WELL DRILLER REPORT

DEPARTMENT OF WATER RESOURCES (DWR)
NOTICE OF INTENTION TO DRILL
MONITOR/PIEZOMETER WELL

Re: City of Phoenix N.W. Service Center
Monitoring Wells

Re: Request for Variance for 5 Monitor Wells

WATER MONITORING WELL

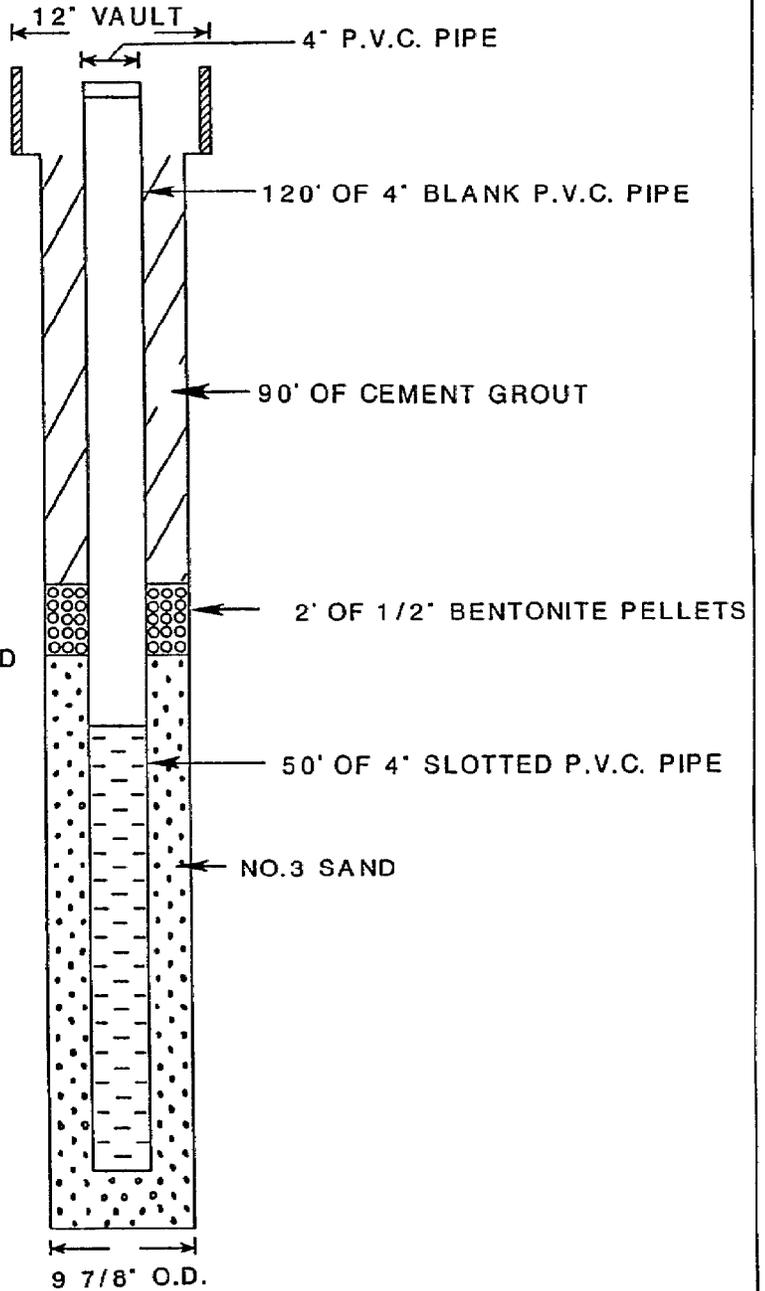
The City of Phoenix has asked us to request notices of intention to drill for five additional monitoring wells at the N.W. Service Center. The location services City of Phoenix vehicles and has heavy traffic. We request a variance on the five wells to include the following:

- The well be completed flush with the ground surface with a water tight vault and a 2' x 2' x 6" concrete pad.
- That the requirement for a 20' steel surface casing be deleted.

We are in receipt of your letter dated June 26, 1986 requesting a construction variance for 5 Monitor Wells. This letter constitutes our approval as described below:

The requirement to incorporate 20 feet of steel surface casing with 1 foot extending above grade is waived. Instead, 4" PVC casing may be used with the required grout seal, and the casing may terminate below ground level, with a steel water tight vault constructed around the well. Also, a water tight cap shall be provided for the 4" PVC casing.
